Docket Number:	15-AAER-02
Project Title:	Pool Pumps and Spa Labeling
TN #:	212762
Document Title:	APSP Comments on Portable Electric Spa
Description:	N/A
Filer:	System
Organization:	The Association of Pool & Spa Professionals (APSP)/Jennifer Hatfield
Submitter Role:	Public
Submission Date:	8/12/2016 11:43:09 AM
Docketed Date:	8/12/2016

APSP Portable Electric Spa Comment on Docket No. 15-AAER-02

August 12, 2016

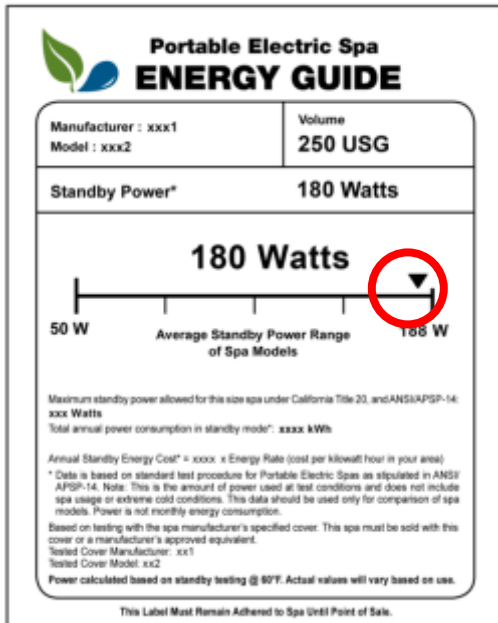
The staff report references section 6.3.1 is to be omitted from the adoption of APSP-14. 6.3.1 is not a valid section. CEC staff is looking to reference where the exercise spa energy formula is $5 \cdot V^{2/3}$. The published September 2014 Standard references the exercise spa allowed energy formula in 8.2.

We request that the CEC update the language to reference the accurate section.

See the example below: Which is better?

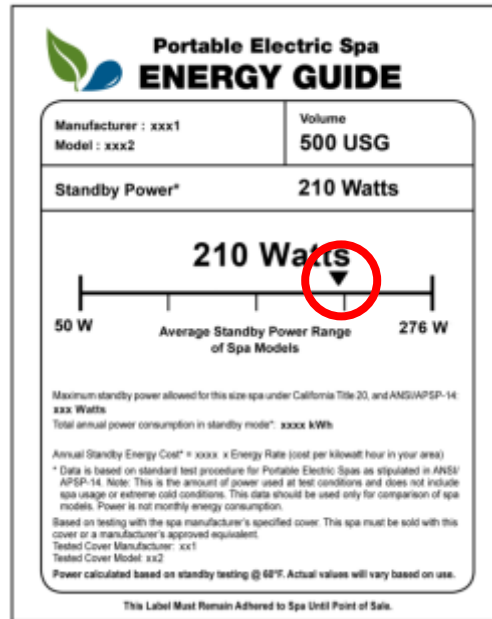
It was proposed to change the energy bar chart on the label from an industry comparing label to a spa specific label. We are concerned that when the label max energy is the max energy allowed for the spa, the label will show how it compares against itself or another spa of the same volume. The consumer will now no longer be able to compare units across the industry in a simple and common manner. Customers don't shop by water volume, but by overall size, cosmetics, features, and performance. What can easily happen is that customers will see large spas appearing more efficient.

We request that the label be left unchanged so the customer can make better decisions as they shop spas model by model.

To a consumer, B is better because the unit is more “efficient”. However, to the manufactures and State of California, A is better because it uses less energy.
